Planning & Zoning Board Public Hearing

March 3, 2020 at 6:00 p.m.

Planning & Zoning Board Staff Report for March 3, 2020 Meeting

[SPR #20-02. Request of Tipu Keen for: Approval to construct a 634-square foot addition to the one-story, single-family home located at 2122 Lake Drive on Lake Killarney, zoned R-1A.](#)

1 SITE PLAN
 1" = 30'-0"

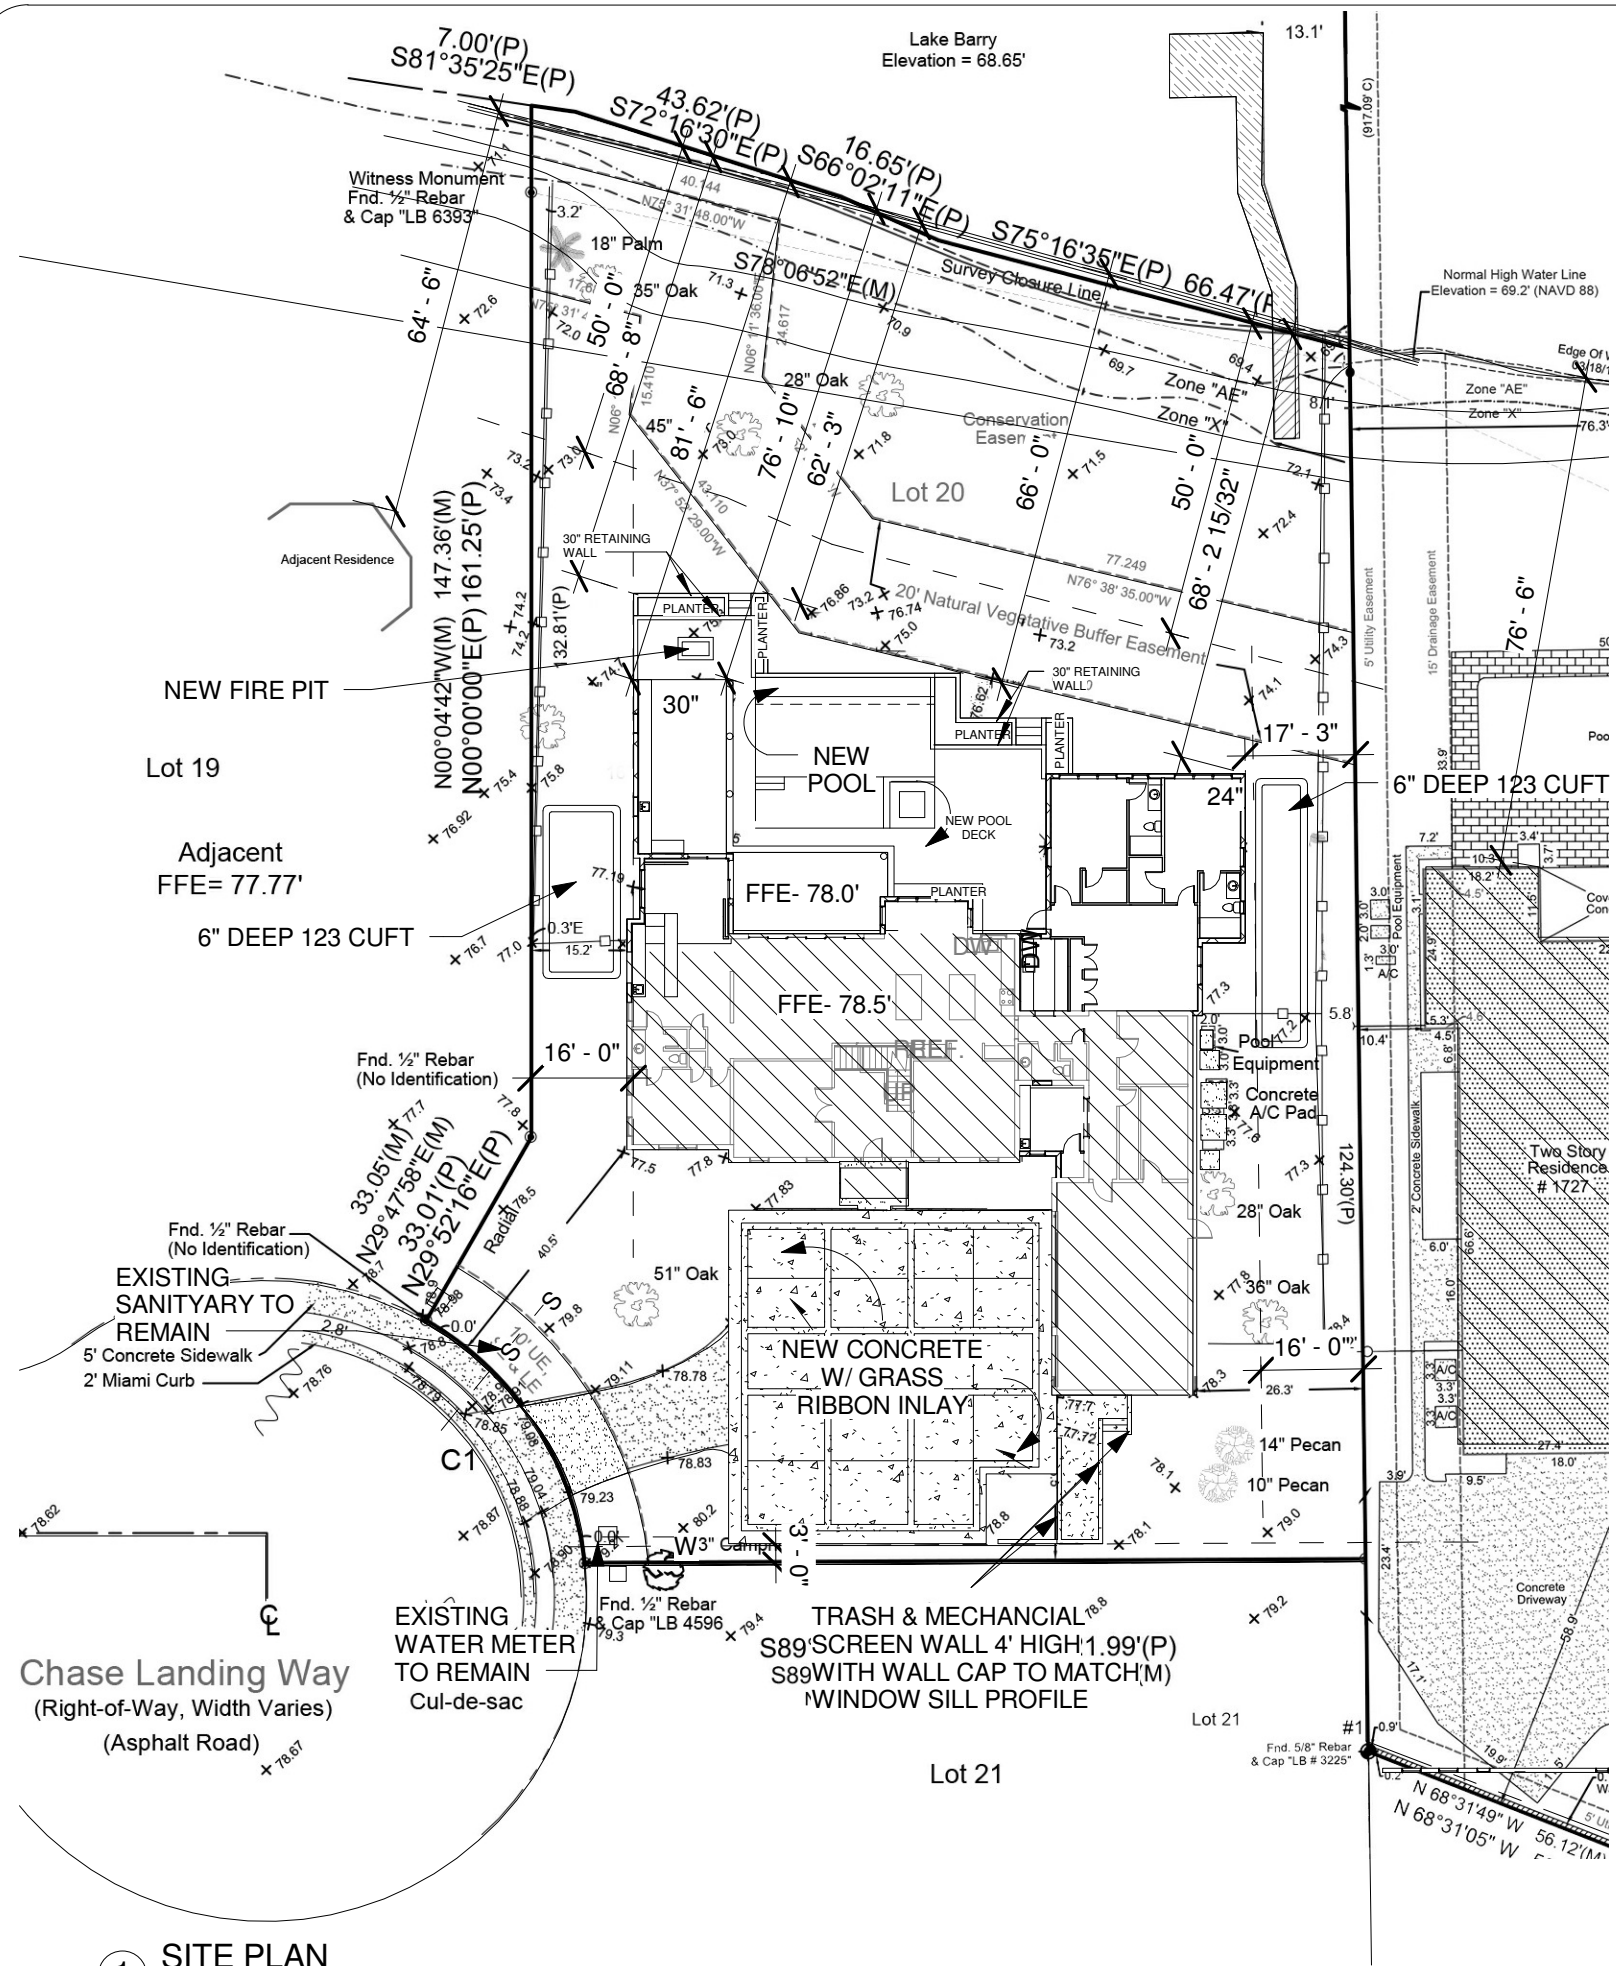
The purpose and intent of the lakefront lots section of the code states that existing trees shall be preserved to the degree reasonably possible, and the appearance of the property and the shore when viewed from the water will be kept as natural as reasonably possible. The applicant is proposing to remove six palm trees along the edges of the lot, but is preserving all of the large oak trees in the rear of the lot, as well as the 51-inch diameter oak tree in the front of the lot.

The code limits walls and swimming pool decks facing the lake in excess of three feet in height. This lot is relatively flat, but does have a minimal grade drop where the applicant is proposing the new pool/deck area in the rear of the lot. The pool/deck area is meeting the three-foot height maximums along the sides of the lot, but is exceeding this by two feet in the center of the pool/deck. However, the applicant is proposing two 30-inch landscaped terraces to minimize the effect of the deck height towards the lake.

The code requires retention of storm water so that storm water flowing over a lakefront lawn area does not carry with it into the lake any fertilizers, herbicides, or other chemicals that affect the water quality of our community's most precious assets. The amount of impervious surface on the lot determines the depth/size of the retention needed. The applicant is proposing several storm water swales throughout the lot that are sized to meet the city's code requirements.

Staff has determined that the average lakefront setback to be 70 feet. The applicant is proposing a 68-foot lakefront setback to the home in the eastern portion of the lot and a 76-foot setback in the western portion of the lot. While the eastern setback is two feet closer than the average, these setbacks are comparable to the lakefront setback of the two adjacent lakefront homes. The applicant is also requesting a 62-foot setback to the pool and deck areas, but those structures are at grade and do not impair any lake views. Therefore, P&Z has the authority to make the judgement call whether "lake views are being unduly impaired" with the setbacks as presented. It appears to staff that the proposed setbacks meet the intent of the code.

Staff recommendation is for approval, with one condition:

- 1. Subject to conformance to the Windsong HOA approvals and conditions.*

1. The new Driveway revision to allow for additional parking appears to exceed the Minimum 50% Front Yard Landscape requirement and is excessive in length. Therefore, as discussed, please revise to allow for greater landscape areas for both the street side as well as the area between the new parking and the garage / service courtyard. If reduced to 30' in length along the south boundary, this should successfully accomplish (2) parking spaces as well as a back up indentation for the garage. Additionally, please add the Front Yard Impervious and Green areas to your calculations chart.

2. The minimum landscape area between the driveway, sport court and the property line is 3'-0", therefore, please revise and add the necessary minimum dimension to accomplish this requirement.....currently as drawn, it appears to be closer than allowed.

3. The new "Sports Court", if used for basketball, must have landscape installed to screen the equipment from views by adjacent properties within Windsong.

4. Exterior lighting for the "Sports Court" is not allowed.
5. Please indicate that the new Service Courtyard will be at least 4'-0" in height, made of concrete block with a stucco finish to match the existing residence, as required per the Windsong CC&R's.....currently there are no specific drawings for this area.

These home plans have received approval from the Windsong Homeowners Association (HOA) Architectural Review Board. As shown in the attached letter from the HOA, there were a few comments related to a sport court that the applicant has removed from these plans.
